Name: Country Club Estates – SE G Road / 12th Street- Final Plat/Plan

TITLE HEADING: Final Plan/Plat - Country Club Estates

Title: COUNTRY CLUB ESTATES, Final Plat and Plan

FILE: #21-94
DATE: February 16, 1994
STAFF: Kathy Portner
REQUEST: Final Plat/Plan--Country Club Estates
LOCATION: SE corner of G Road and 12th Street
APPLICANT: Sidney Gottlieb

BLOCK 1
1

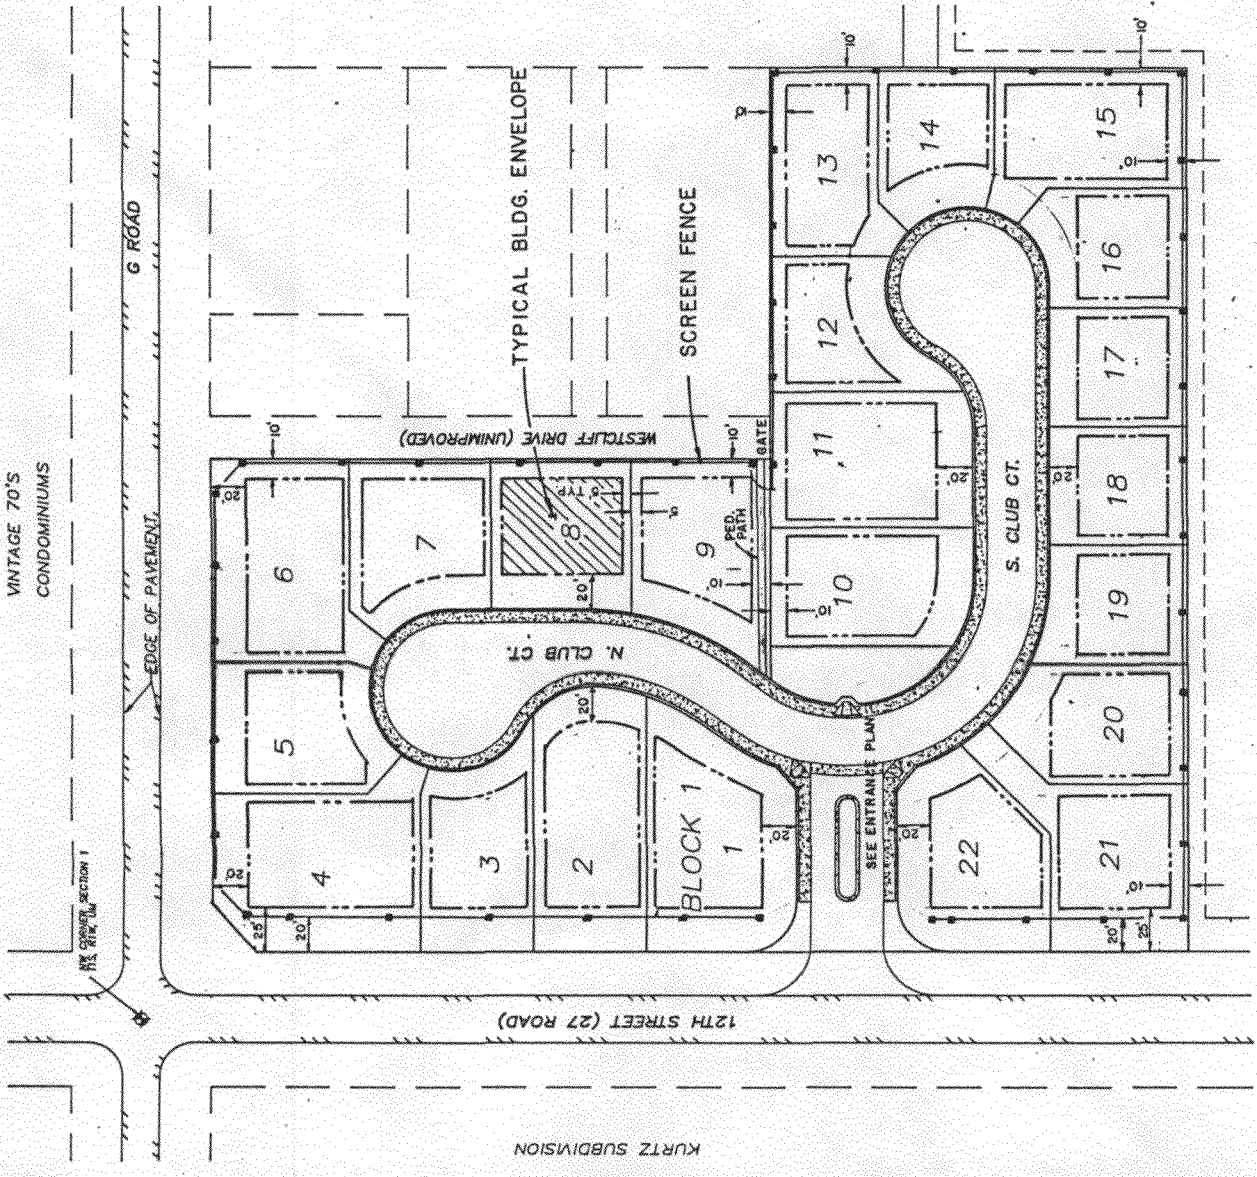
Big problem - golf cart easement. It is my understanding that the golf cart easement was provided to keep the golf carts off of "G" Road as much as possible for safety reasons. Where the proposed golf cart easement is proposed does not do this. I would recommend the connection to the golf cart easement be across Lot 14, somehow. Maybe you can make Lot 15 smaller and make the connection between Lot 13-14; or make Lots 13 & 15 bigger and eliminating Lot 14, making it an easement only. The increase of Lots 13 & 15 can also benefit Lots 10-12 and 16-21. You may be able to change the driveway access to Lots 13 & 15 to incorporate the golf cart easement. The existing proposed cart easement duping onto Westcliff Drive to me is not acceptable.

9. The pedestrian/golf cart easement access to Westcliff Drive is not acceptable as the only connection. An easement will be required to tie into the easement that was required of the Horizon Park East Subdivision that is adjacent to lot 14 of this development. Lots at the east end of S. Club Ct. must be reconfigured to allow for that access. Fences and/or gates will not be allowed to cross this easement. The pedestrian easement between lot 9 and 10 should also be retained to provide access the future developments to the east. The easement must be a minimum of 12' wide. The easement may not be fenced. Both pedestrian/golf cart easements must be developed with a paved path a minimum of 8' wide. Maintenance of the paths will be the responsibility of the homeowners.

An alternative location for the Cart Path has been added to the Site Development Plans between Lots 14 and 15.

8. An Avigation Easement is attached.
9. An alternative location for the Cart Path has been added to the Site Development Plans between Lots 14 and 15. Since the Pathway will be constructed to meet City Standards it is assumed that all maintenance of the path will be done by the City.
